Considerations on how to express receiver sensitivity in P802.3cu

Peter Stassar, Huawei

IEEE P802.3cu Task Force ad hoc call, 5 May 2020

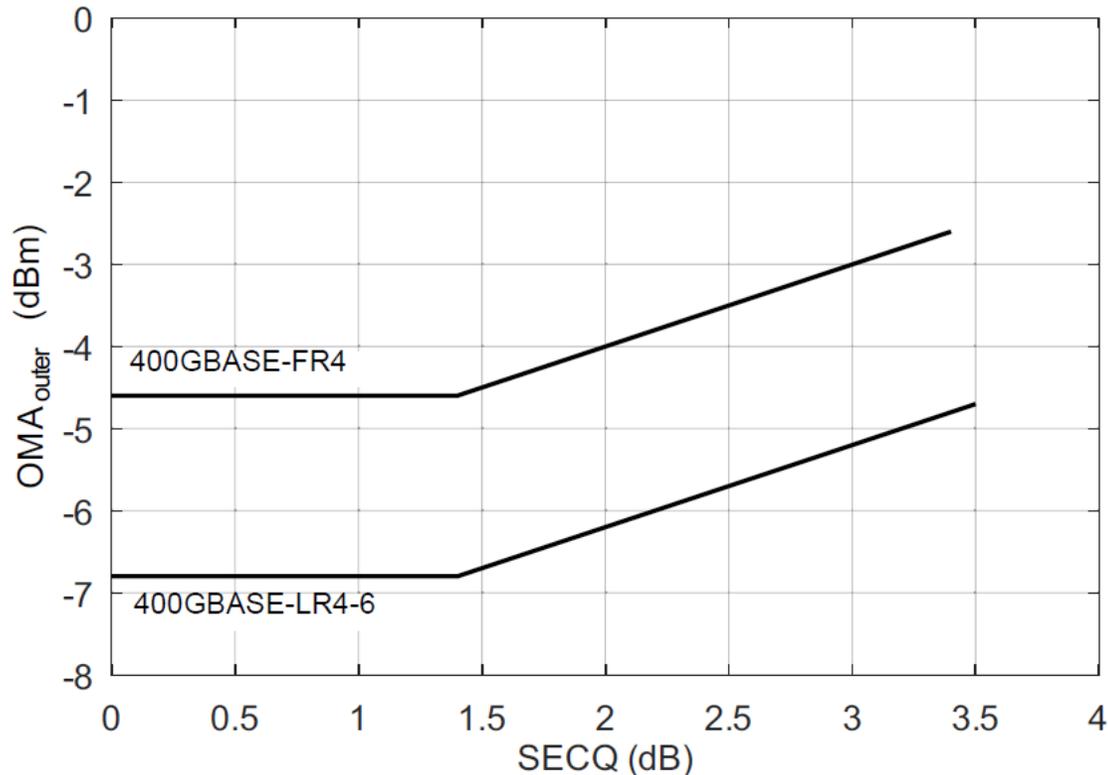
- That therefore RS minus SECQ should be specified as a fixed value and not as $RS = SECQ - 1.7$ dB (for $ER \geq 4.5$ dB case)
- The author believes there is an important difference between Tx OMA_{outer} and RS

- The receiver sensitivity RS depends on the SECQ (or TECQ) of the transmitter used, which is generally unknown in an interworking condition.
- Thus in this case SECQ (or TECQ) is a variable and therefore RS follows the curve in Figure 151-6

- RS is flat for SECQ < 1.4 dB and above that increasing linearly with SECQ
- It's very appropriate to express RS as "SECQ – 6 dB" for SECQ ≥ 1.4 dB for the 400GBASE-FR4 example

- For a transmitter TDECQ is not a variable, but rather a fixed value.
- Therefore we don't need to express OMA_{outer} in the same way as RS
- It is the author's view that we should maintain the way Tx OMA_{outer} and RS are specified in D2.1.
- However if there is consensus that we need to align the representation of Tx OMA_{outer} and RS, the author feels that it would be better to consider the reverse approach and represent Tx OMA_{outer} as (for the 400GBASE-FR4 example):
 - Tx OMA_{outer} (min) = -0.3 dBm for TDECQ < 1.4 dB
 - Tx OMA_{outer} (min) = TDECQ – 1.7 dBm for TDECQ ≥ 1.4 dB
- The author feels that this would significantly increase the readability of the specification
